UNITED STATES PATENT AND TRADEMARK OFFICE

Office Action Summary	Application No. 10/577,863	Applicant(s) ISHIHARA, MASAMICHI
	Examiner WILLIAM HARRISTON	Art Unit 2826

DETAILED ACTION

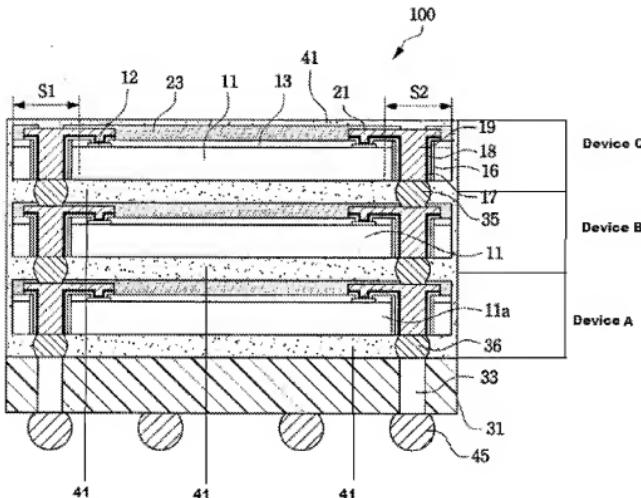
3. Claims 1-7, 10-23 and 47-51 are rejected under 35 U.S.C. 102(b) as being anticipated by Lee et al. (US 20050046002).
4. Examiner's note: To easily identify which common elements belong to which semiconductor device the Examiner has designated elements belonging to the first, second and third semiconductor devices with a, c, and b

5. Regarding claim 1, Lee discloses a stacked semiconductor device consisting of a first semiconductor device (Device A in annotated figure 3) having outside electrode terminals (36 in figure 3) on a lower surface thereof, a second semiconductor device (Device C in annotated figure 3) electrically connected with said first semiconductor device (See paragraph 0028 lines 1-3) and secured on said first semiconductor device, said first semiconductor device comprising:

a first semiconductor substrate (11a in figure 3);

a first multilayer wiring part (21a and 23a in figure 3) on said first circuit elements and configured of a first wiring (21a in figure 3) electrically connected with said first circuit elements (12a in figure 3, see paragraph 0027 lines 13-15) and a first insulating material layer (23a in figure 3), the first wiring (21a in figure 3) and the first insulating material layer (23a in figure 3) being stacked alternately with the first insulating material layer being an uppermost layer;

a first insulating layer (41 between Device A and Device B in annotated figure 3) for covering said first insulating material layer (23a in figure 3) of said first multilayer wiring part and provided all over said first semiconductor substrate, said first insulating layer (41 in figure 3) is a support member of said first semiconductor substrate;

a second insulating layer (41 between element 31 and Device A) for covering a second main surface of said first semiconductor substrate (11a in figure 3) that is opposite the first main surface of said first semiconductor substrate;

a plurality of first post electrodes (35 in figure 3) on said first wiring (21a in figure 3) of said first multilayer wiring part and each having a top surface and side surfaces, the top surfaces of said first post electrodes exposed from a surface of said first insulating layer (41 between Device A and Device B in figure 3) and all the side surfaces of said first post electrodes covered by said first insulating layer;

a plurality of first through-type electrodes (19a in figure 3) penetrating from a specified depth of said first multilayer wiring part (21a in figure 3) to a surface of said second insulating layer (41 between element 31 and Device A in figure 3) through said

first semiconductor substrate (11a in figure 3), said first through-type electrodes insulated from said first semiconductor substrate by a first insulating film (16 in figure 3, see paragraph 0037 lines 1-8) and connected with said first wiring (21a in figure 3) of said first multilayer wiring part; and

said outside electrode terminals (36 in figure 3) connected to said first through-type electrodes (19a in figure 3),

said second semiconductor device (Device C in figure 3) comprising:

a second semiconductor substrate (11c in figure 3);

second circuit elements (12c in figure 3) formed at a first main surface of said second semiconductor substrate;

a second multilayer wiring part (21c and 23c in figure 3) on said second plurality of circuit elements (12c in figure 3) and configured of a second wiring (21c in figure 3) electrically connected with said second circuit elements (see paragraph 0027 lines 13-15) and a second insulating material layer (23c in figure 3), the second wiring and the second insulating material layer being stacked alternately with the second insulating material layer being an uppermost layer;

a third insulating layer (41 above Device C in figure 3) for covering said second insulating material layer (23 in figure 3) of said second multilayer wiring part and provided all over said second semiconductor substrate, said third insulating layer (41 above Device C in figure 3) is a support member of said second semiconductor substrate;

a fourth insulating layer (41 between Device C and Device B in figure 3) for

covering a second main surface of said second semiconductor substrate that is opposite the first main surface of said second semiconductor substrate; and a plurality of second through-type electrodes (19c in figure 3) penetrating from a specified depth of said second multilayer wiring part to a surface of said fourth insulating layer (41 Between Device b and Device C in figure 3) provided to pierce through said second semiconductor substrate (11c in figure 3), said second through-type electrodes insulated from said second semiconductor substrate by a second insulating film (16c in figure 3, see paragraph 0037 lines 1-8) and connected with said second wiring (21c in figure 3) of said second multilayer wiring part,

in said first semiconductor device (Device A), said first through-type electrodes (19a in figure 3) are at the lower surface thereof and are provided with said outside electrode terminals (45 in figure 3), and

said second post electrodes (35 in figure 3) at a lower surface of said second semiconductor device (Device C) are electrically connected with said first post electrodes (35 in figure 3) at an upper surface of said first semiconductor device through joints.

Examiner has interpreted a joint to be a location where two elements make contact.

6. Regarding claim 2, Lee discloses the device of claim 1 for the reasons stated above. Lee further discloses:

a third semiconductor device (Device B in figure 3) stacked and secured between said first semiconductor device (Device A) and said second semiconductor device

(Device C), wherein said third semiconductor device comprises:

a third semiconductor substrate (11b in figure 3);

third circuit elements (12b in figure 3) at a first main surface of said third semiconductor substrate;

a third multilayer wiring part (21b and 23b in figure 3) on said third circuit elements and configured of a third wiring (21b in figure 3) electrically connected with said third circuit elements (see paragraph 0027 lines 11-13) and a third insulating material layer (23b in figure 3), the third wiring and the third insulating material layer being stacked alternately with the third insulating material layer being an uppermost layer;

a fifth insulating layer (41 between Device B and Device C in figure 3) for covering said third insulating material layer (23b in figure 3) of said third multilayer wiring part and provided all over said third semiconductor substrate, said fifth insulating layer is a support member of said third semiconductor substrate;

a sixth insulating layer (41 between device A and Device B in figure 3) for covering a second main surface of said third semiconductor substrate that is opposite the first main surface of said third semiconductor substrate;

a plurality of third post electrodes (35 in figure 3) on said third wiring (21b in figure 3) of said third multilayer wiring part and each having a top surface and side surfaces, the top surfaces of said third post electrodes exposed from a surface of said fifth insulating layer and all the side surfaces of said third post electrodes covered by said fifth insulating layer;

a plurality of third through-type electrodes (19b in figure 3) penetrating from a specified depth of said third multi-layer wiring part to a surface of said sixth insulating layer through said third semiconductor substrate said third through-type electrodes (19b in figure 3) insulated from said third semiconductor substrate by a third insulating film (16b in figure 3, see paragraph 0037 lines 1-8) and connected with said third wiring of said third multilayer wiring part,-and

the third through-type electrodes (19b in figure 3) on upper/lower surfaces of said third semiconductor device are electrically connected with the first through-type electrodes (19a in figure 3) of the first semiconductor device at an upper stage side and the second semiconductor device (11c in figure 3) at a lower stage side through joints (see paragraph 28 lines 1-3).
